Technical Service Bulletin: TSB100603

Released Date: 24-Oct-2012

QSK19 High Pressure Injection Turbocharger Mounting Hardware

Turbocharger Mounting

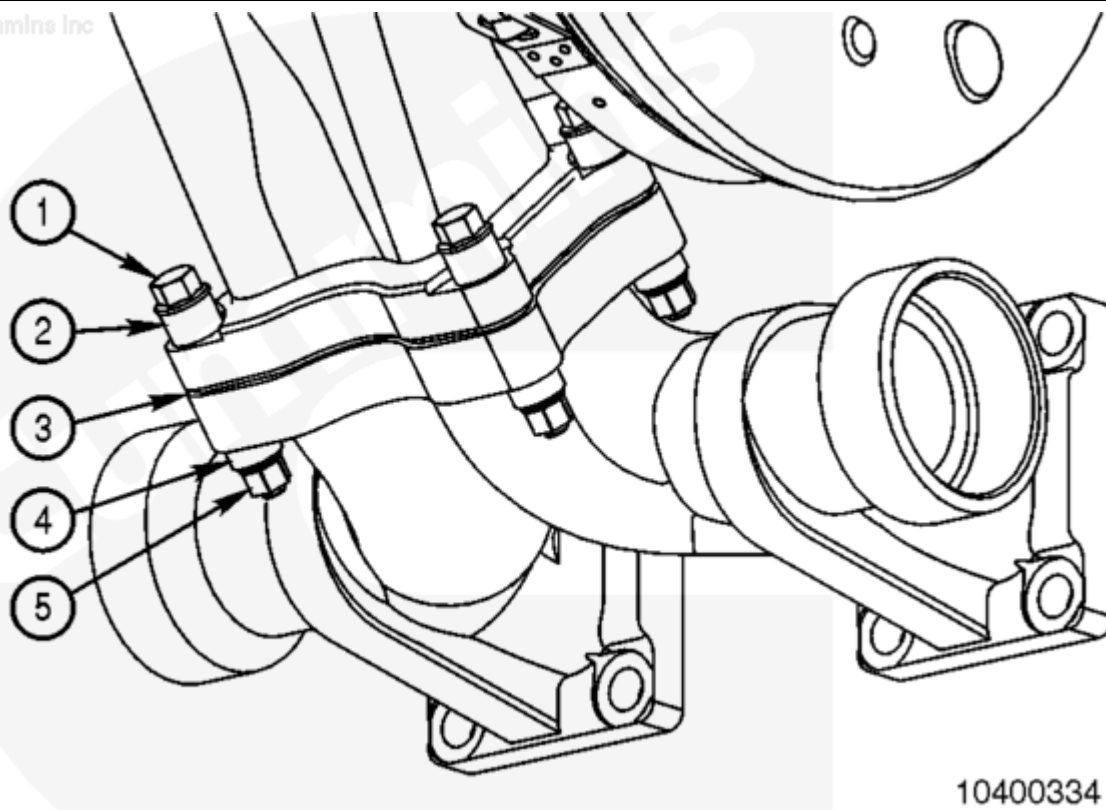
A serious quality problem project (SEY-11005) closed that resulted in the implementation of modular common rail system turbocharger mounting hardware on all 19 liter high pressure injection engines, excluding rail engines and engines with wastegated turbocharger effective 05 May 2011.

In the event of a failure of the high pressure injection turbocharger mounting hardware, the modular common rail system mounting hardware should be installed. The installation of the modular common rail system mounting hardware results in a more robust bolted joint over the current high pressure injection hardware.

The correct mounting configuration for the modular common rail system hardware is illustrated below.

1. Mounting Capscrew
2. 12.7 mm [0.50 in] spacer
3. Gasket
4. 9.6 mm [0.38 in] spacer
5. Locking Nut

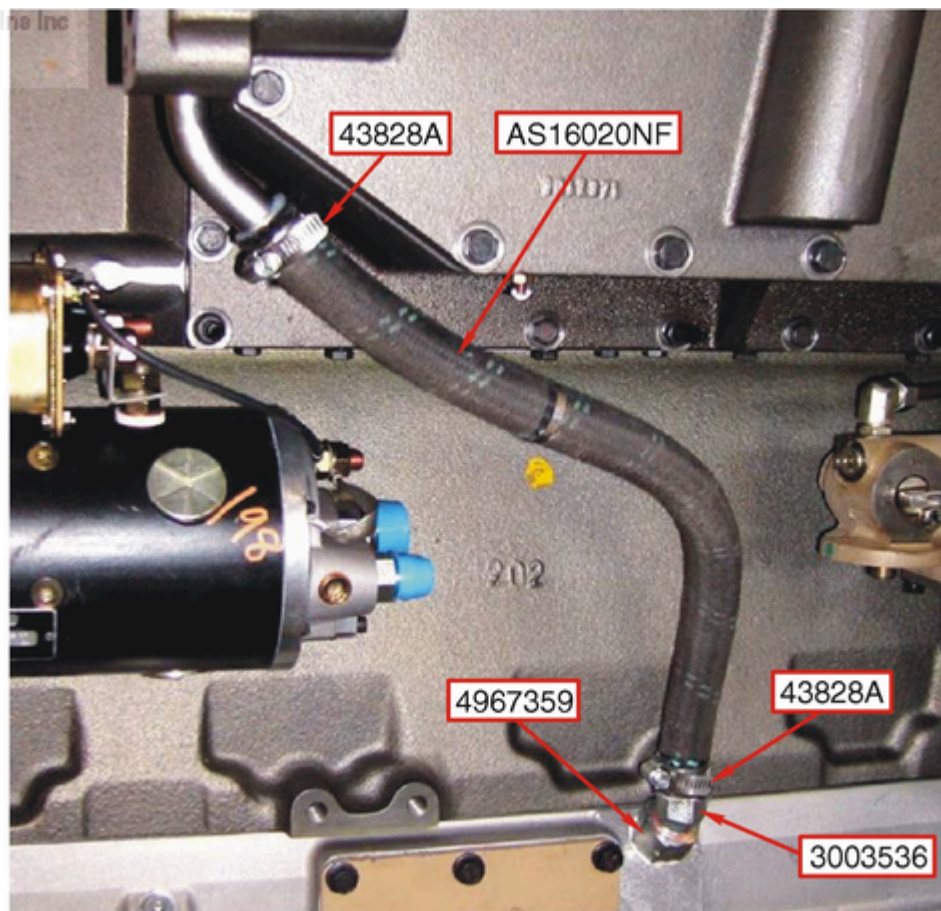
In the event of a turbocharger mounting hardware failure on a rear-out turbocharger arrangement with an on-engine torque converter cooler, it is also necessary to replace the turbocharger drain line connection, if modular common rail system hardware is installed.

1. Place the gasket on the oil drain connection. Install a capscrew with a lock washer up through the connection.

2. Position the turbocharger drain tube connection with gasket to turbocharger. Hand start the first capscrew with a lock washer up through the tube connection into the turbocharger. Install the second capscrew with a lock washer up through the tube connection into the turbocharger.

Torque Value: 45 N-m [33 ft-lb]
